UNOCAL OIL & GAS DIVISION (NSL)

#### **RINCON UNIT #131E**

RE: Request for NSL Order on Rincon Unit #131E

PAD LAYOUT AND TOPOGRAPHY

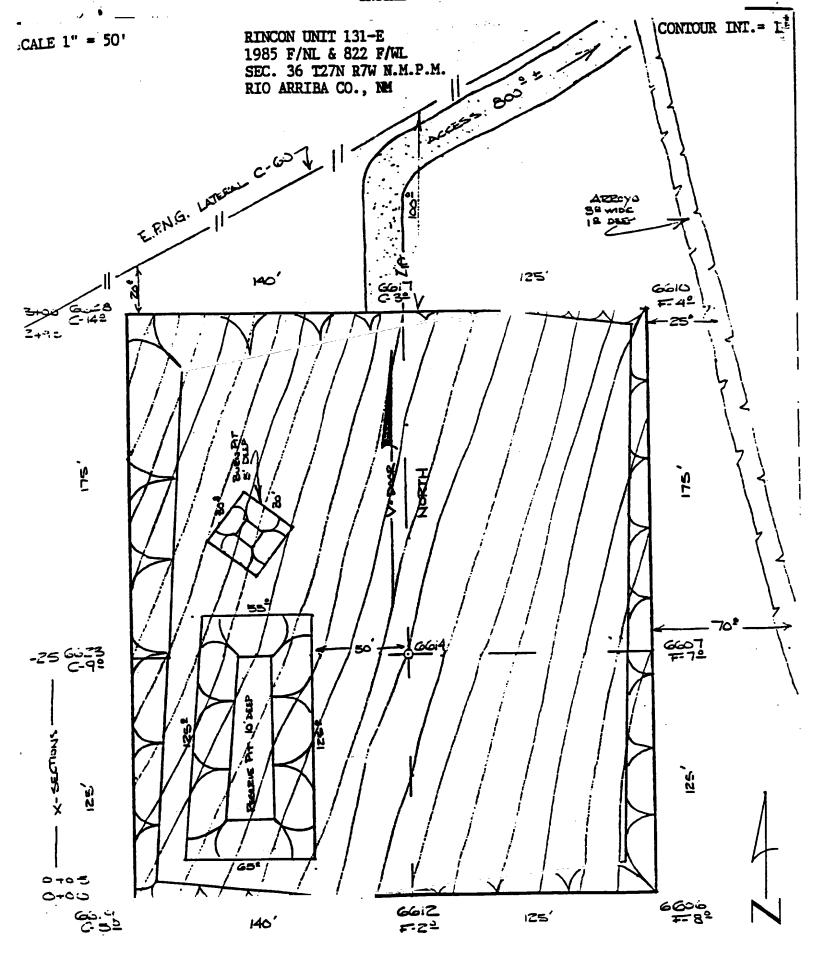
Union Oil Company of California dba Unocal would like to request approval of a non-standard location for the Rincon Unit #131E, located 1985' FNL and 822' FWL, Sec. 36, T27N, R7W, Rio Arriba County, New Mexico. This existing location does not conform to a standard location being 135' too far south and cannot be moved to the north because of an existing natural arroyo to the north and east, in conjunction with the El Paso Natural Gas line to the north (see attached pad layout and topography). Also, Unocal is the sole off-set lease owner/operator.

Unocal also requests approval of a non-standard location for the proposed Rincon Unit 131E. The proposed location does not conform to a standard (Dak./M.V./P.C.) location being approximately 135' too far South. The proposed location cannot be moved to the North due to an existing El Paso Natural Gas lateral line and an existing Arroyo (see attached Pad Layout and topography). Unocal is the sole off-set lease cwner/operator.

RECOMMENDATION: SET THIS APPLICATION FOR HEARING. THE WELL HAS BEEN DRILLED AT AN UNAPPROVED SURFACE LOCATION. I INSPECTED THE SURFACE THAT FALLS WITHIN THE DRILLING WINDOW AND COULD FIND NO REASON WHY THE WELL COULD NOT HAVE BEEN DRILLED AT AN ORTHODOX LOCATION.
